Access Compliance Report

Public Rights-of-Way

(Curb Ramps)

Intersection ID: 13539	Main Street: PINTA_CT	Cross Street: TRYSTING_RD	Location: NW
ADA ID: BD9995F227CA	Ramp Type: Perp	Initial Pass/Fail: Fail	Overall Compliance: No
Codes/Mitigation Info/Possible Solution		Field Measurements/Component Compliance	
Severity Score: 21.25

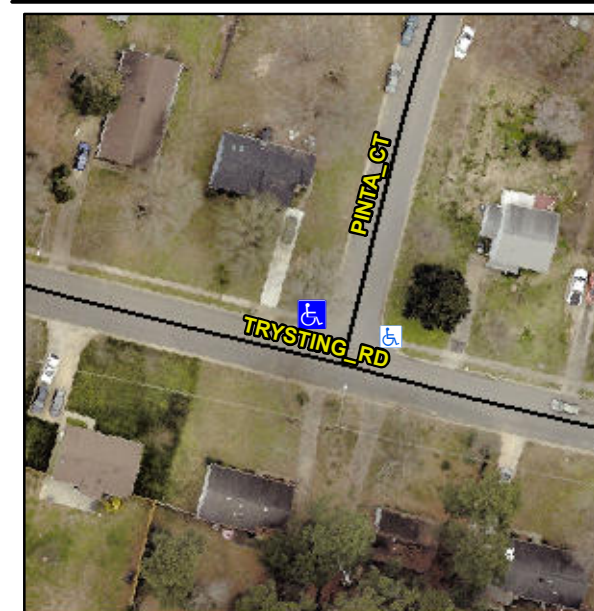
Not Found, R304.5.1, R304.5.3

Compliance	Description	Data	Compliance	Description	Data
N/A	Ramp Length (in)	50.0	Yes	Ramp Slope (%)	6.4
No	Ramp Width (in)	47.0	No	Ramp XSlope (%)	5.1
N/A	Flare Type LT	N/A	N/A	Flare Type RT	N/A
N/A	Flare Slope LT (%)	N/A	N/A	Flare Slope RT (%)	N/A
N/A	Flare Traversable LT?	N/A	N/A	Flare Traversable RT?	N/A
N/A	Landing Length (in)	N/A	N/A	DWS Provided?	N/A
N/A	Landing Width (in)	N/A	N/A	DWS Contrast?	N/A
N/A	Landing Slope (%)	N/A	N/A	DWS Length (in)	N/A
N/A	Landing X Slope (%)	N/A	N/A	DWS Full Width?	N/A
N/A	Landing Curb? (Y/N)	N/A	N/A	DWS Offset (in)	N/A
N/A	Shared Landing?	N/A			
N/A	Gutter Ponding?	N/A	N/A	Gutter Slope (%)	N/A
N/A	Gutter Lip Ht (in)	N/A	N/A	Gutter X Slope (%)	N/A
N/A	Painted X Walk1?	No	N/A	Painted X Walk2?	N/A
	X Walk 1 Direction	To E		X Walk 2 Direction	N/A
N/A	X Walk 1 Width (in)	N/A	N/A	X Walk 2 Width (in)	N/A
	X Walk 1 Slope (%)	0.6		X Walk 2 Slope (%)	N/A
	X Walk 1 X Slope (%)	2.8		X Walk 2 X Slope (%)	N/A

Remove & Replace Entire Ramp.
